AIA
Austin

CodeNEXT Charrette 2 Report

Executive Summary

Figure 1.1: Neighborhood development under Draft 2.0

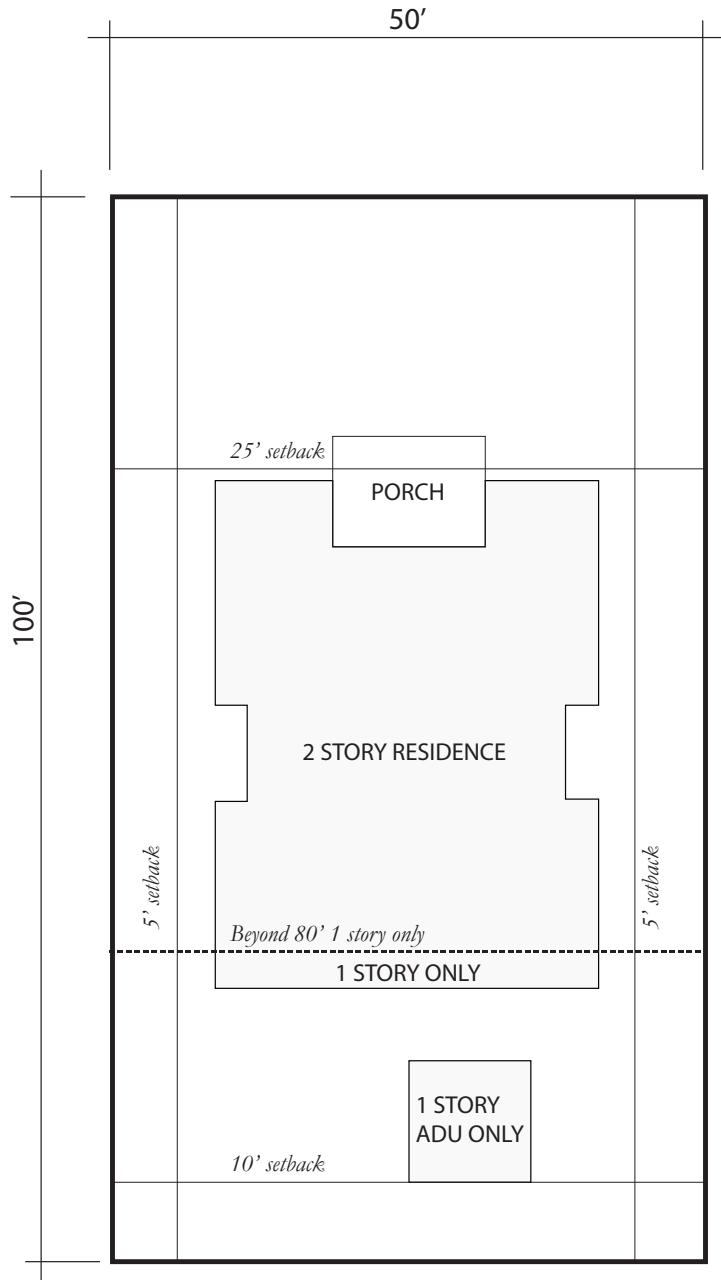
- The prescriptive form-based standards from the first draft have been removed, but new height restrictions for base zones hinder design options much like our current code does.

- The front-yard building setbacks have been pushed back to match current 25-foot setbacks, which does little to activate the streetscape. It also doesn't achieve the vision of Imagine Austin for a better-connected neighborhood.

- Maximum building height measurements are shown to be taken from the finish grade, instead of natural grade, but there is no direction of how to interpret this for sloped grades. It is unclear how this will affect the building form.

- The parking requirement of one space per unit along with the 25-foot setback from the street and the maximum 1/3 rule for cars on the front facade of the building means that parking in the backyard will be necessary for many single-family R3C zoned lots.

LANDSCAPE PLAN

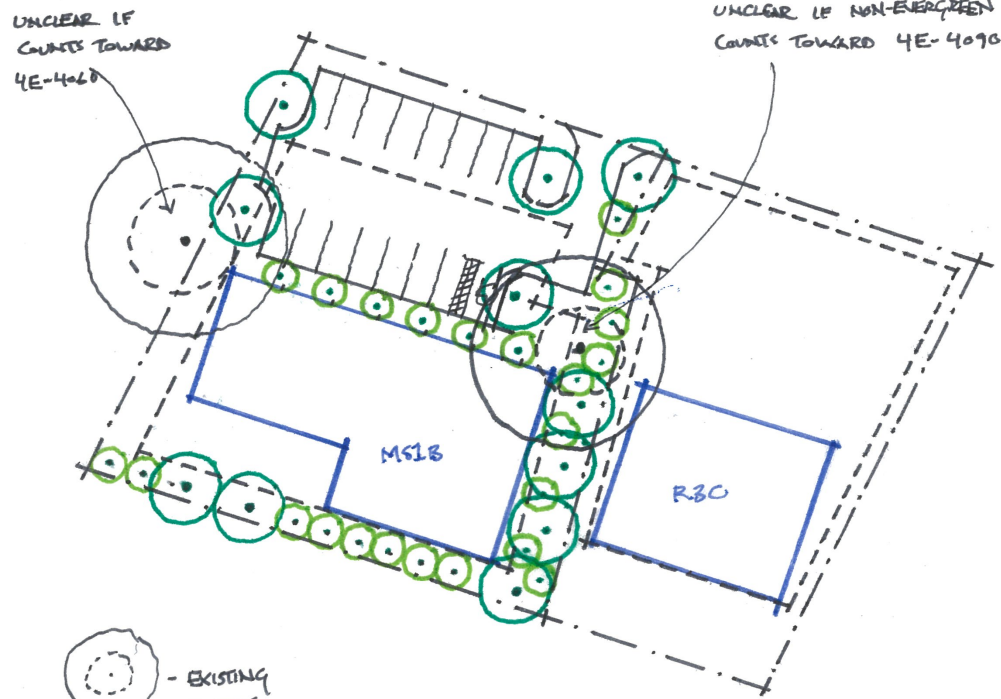
23-4E-4040 FRONT YARD PLANTING

MS1B - (3) SHADE TREES, (8) ORNAMENTAL TREES

23-4E-4060 FOUNDATION BUFFER

MS1B - (6) ORNAMENTAL ~~SHADE~~ TREES (SIDEWALK DOESN'T FIT)

23-4E-4060 SURFACE PARKING TREE ISLANDS

MS1B - (4) SHADE TREES (2 PARKING SPACES REMOVED)

↑ PARKING BAY REQS, NOT LANDSCAPE

Figure 3.3: Webberville Rowhouse Study

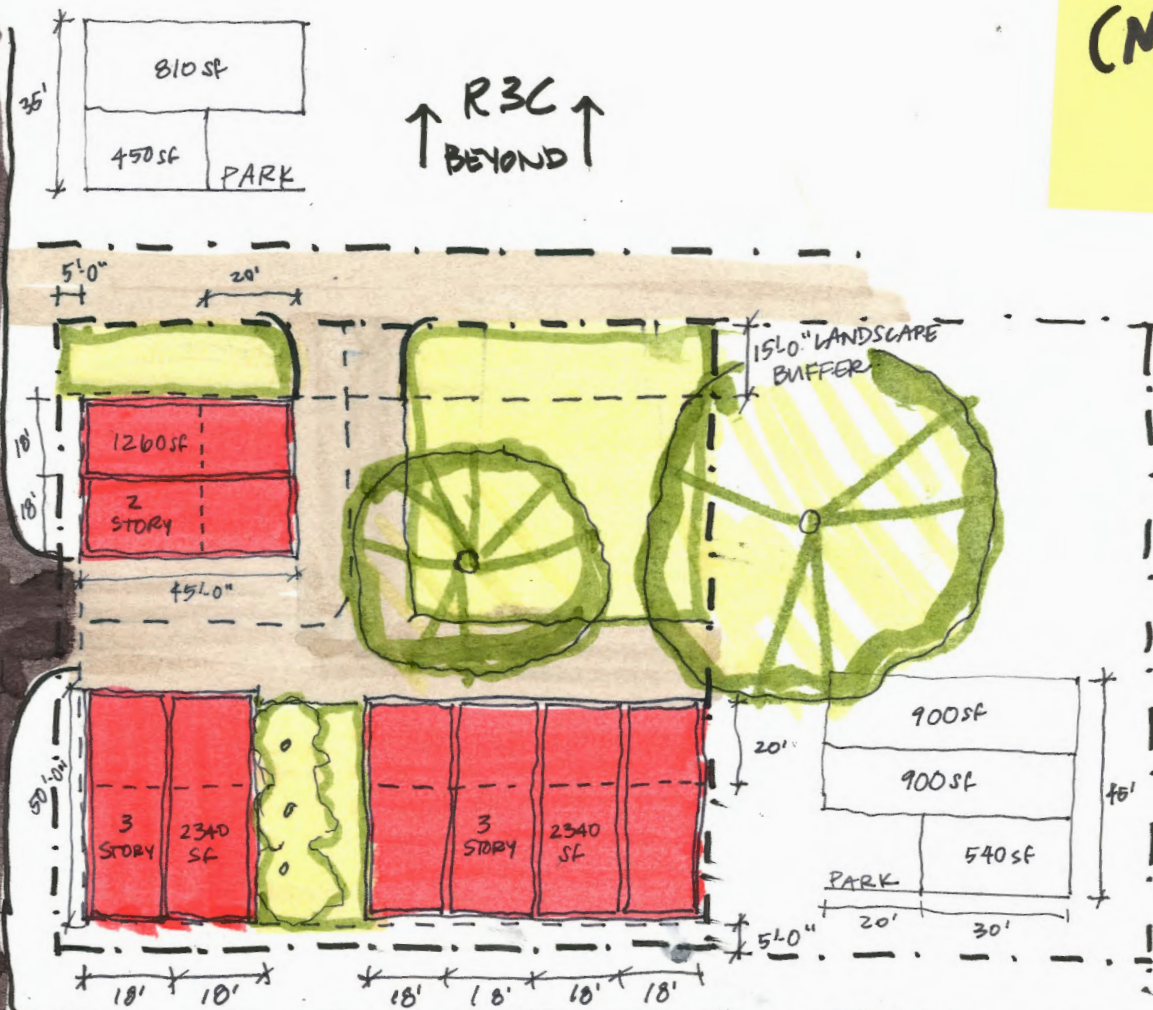
★ PARKING ASSUMES
1 ROWHOUSE = 1 UNIT -
NOT GROUP HOUSING ★
(unclear in code how
to count, what qualifies
as group housing)

Figure 7.1: 5th and Colorado test site developed as office under the current LDC vs. CodeNEXT 2.0

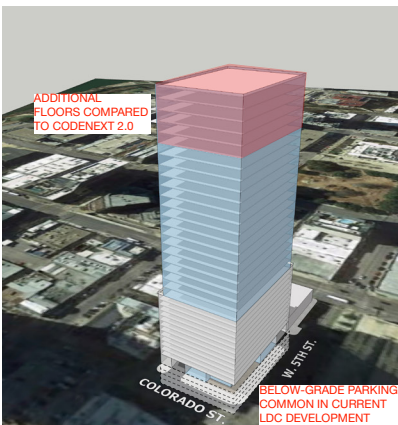
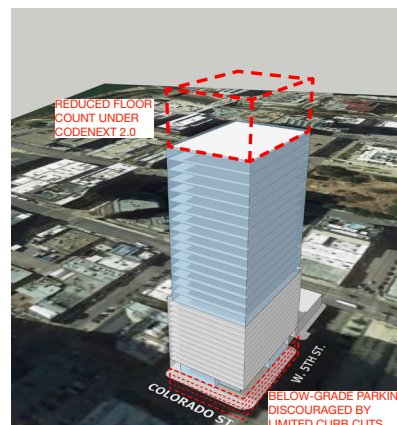
OFFICE UNDER LDC:
 34 Stories - 402' Tall
 445,250 GSF
 870 Parking Stalls
 18.9:1 FAR Achieved

OFFICE UNDER CODENEXT 2.0:
 30% Yield Reduction from LDC Massing
 29 Stories - 332' Tall
 342,750 GSF
 663 Parking Stalls
 14.6:1 FAR Achieved
